**CITY OF PANAMA CITY BEACH
PLANNING BOARD**

MEETING DATE: June 9, 2021
MEETING TIME: 1:00 P. M.
PLACE: City of Panama City Beach City Hall

Staff Review: East Lake Creek II

Appendix A:
PUD Conceptual Plan

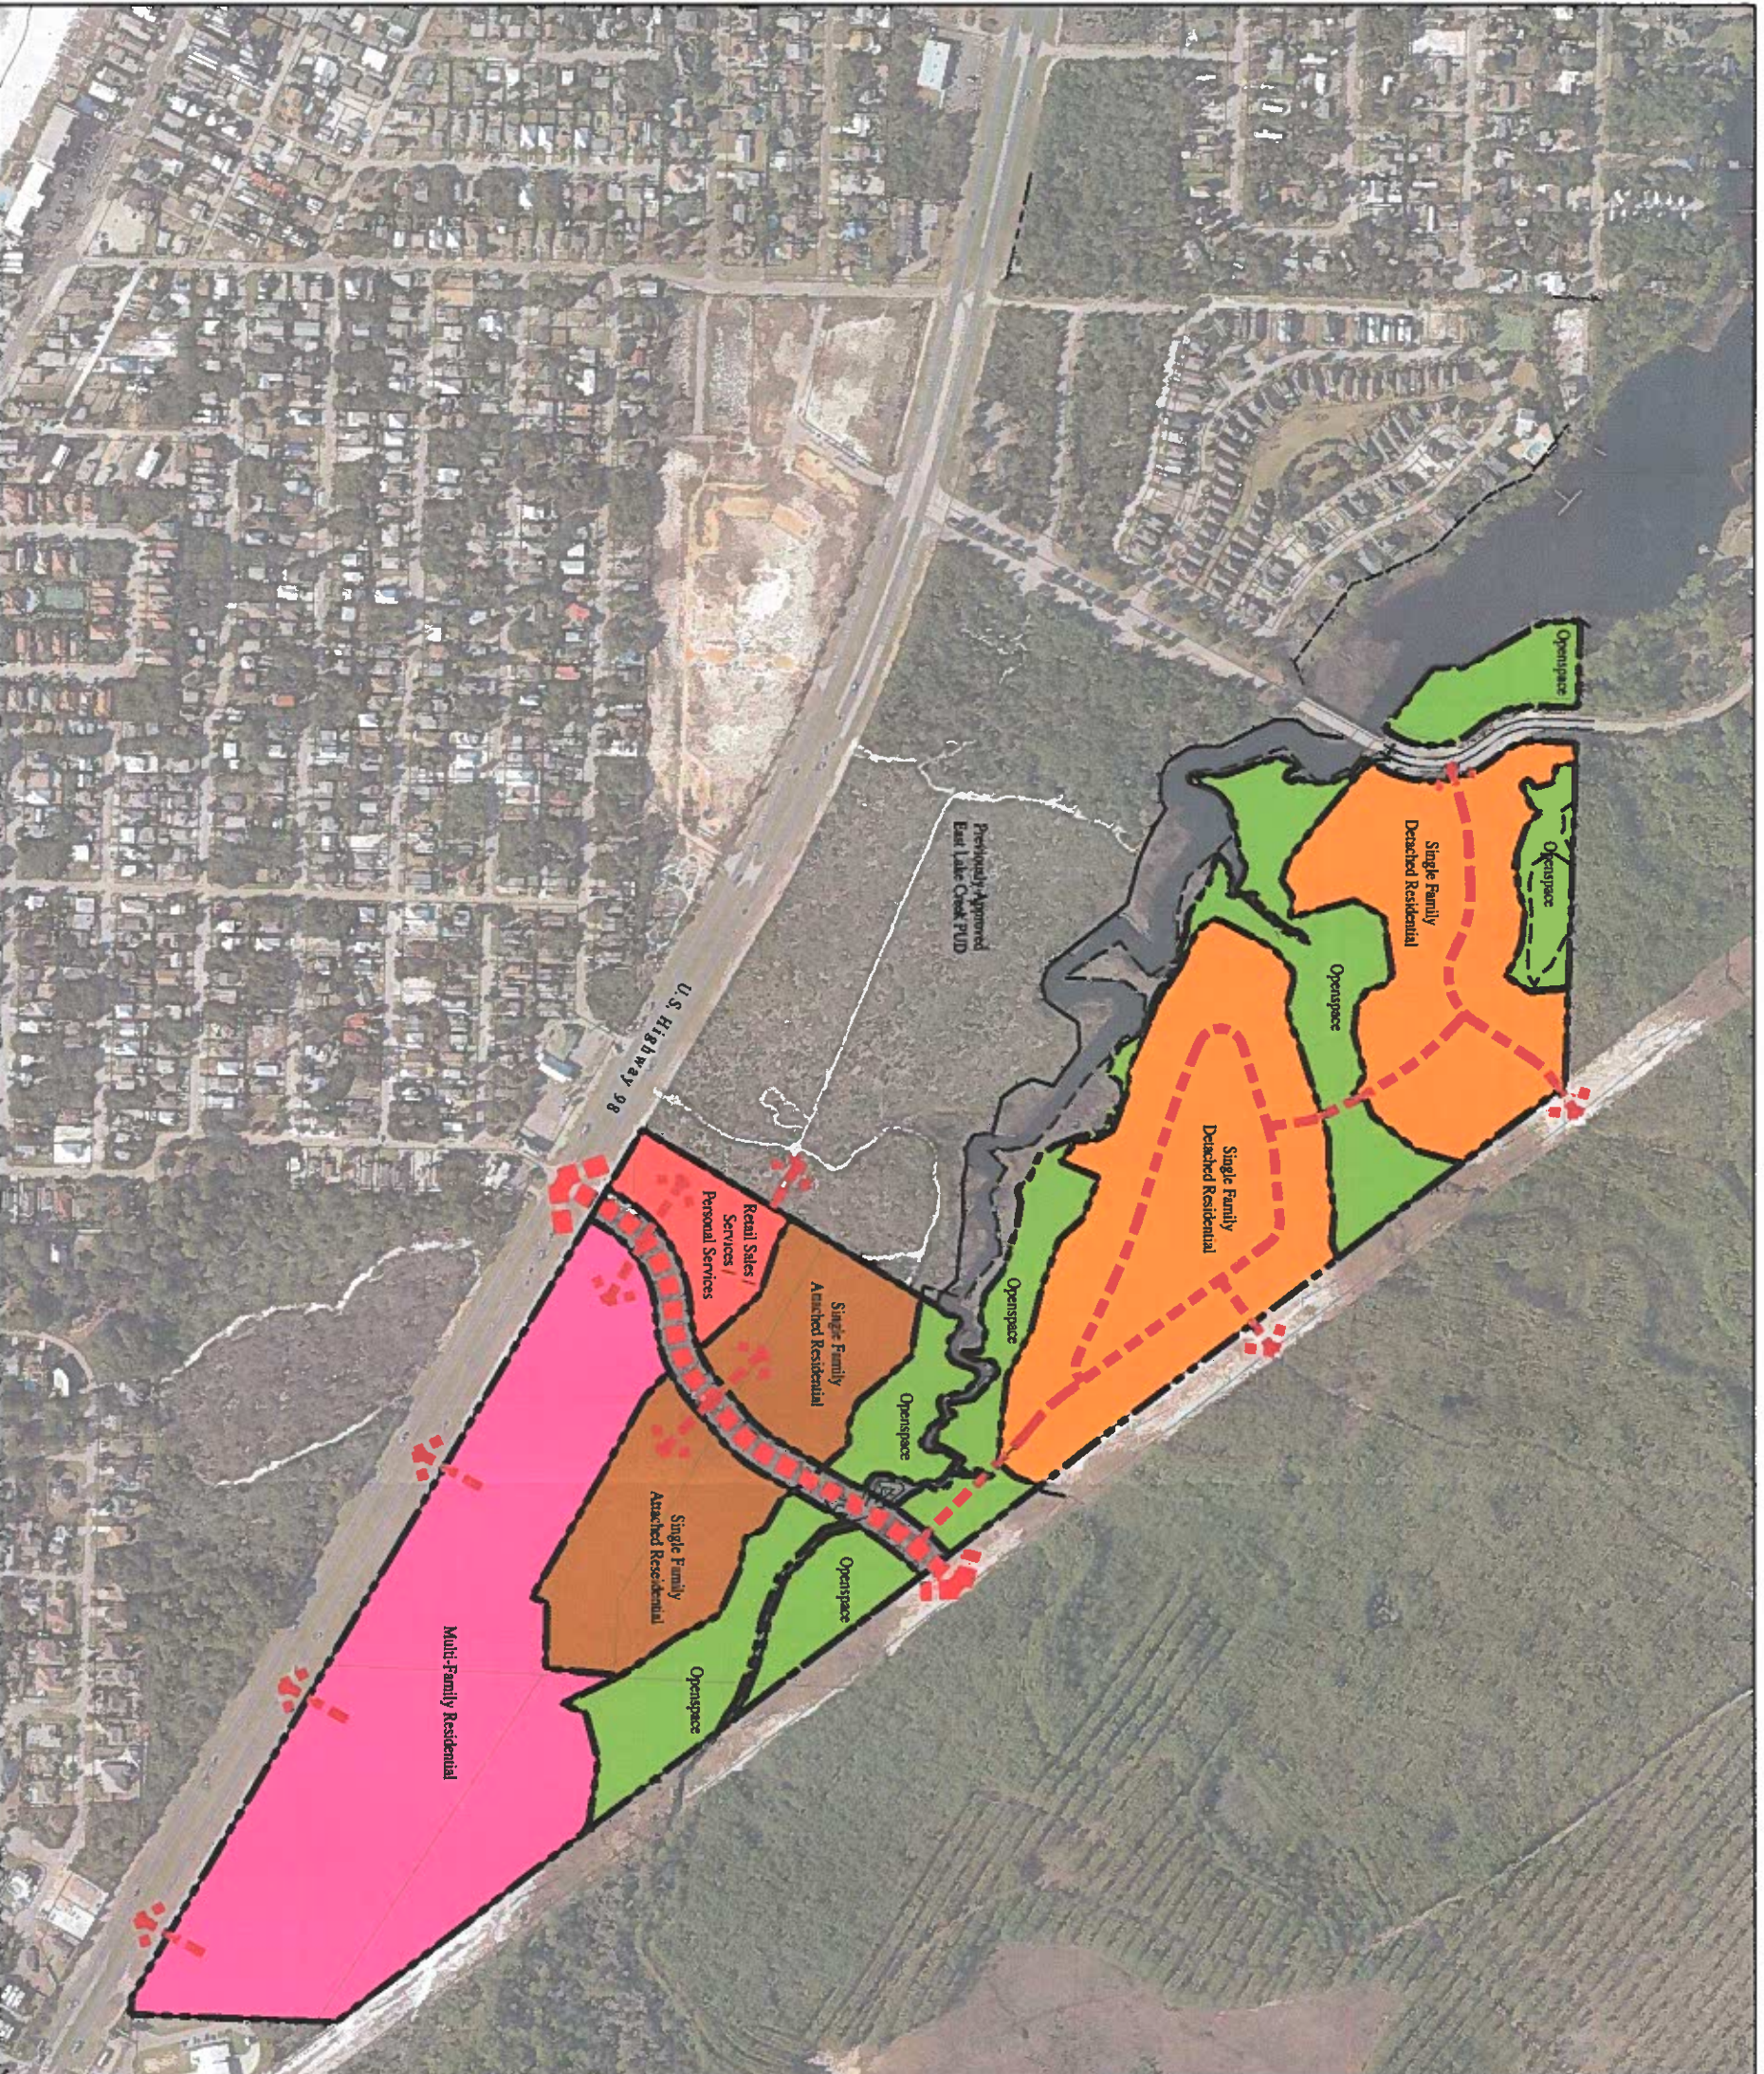
Staff analysis: *The submittal addresses these issues on the Conceptual Plan.*
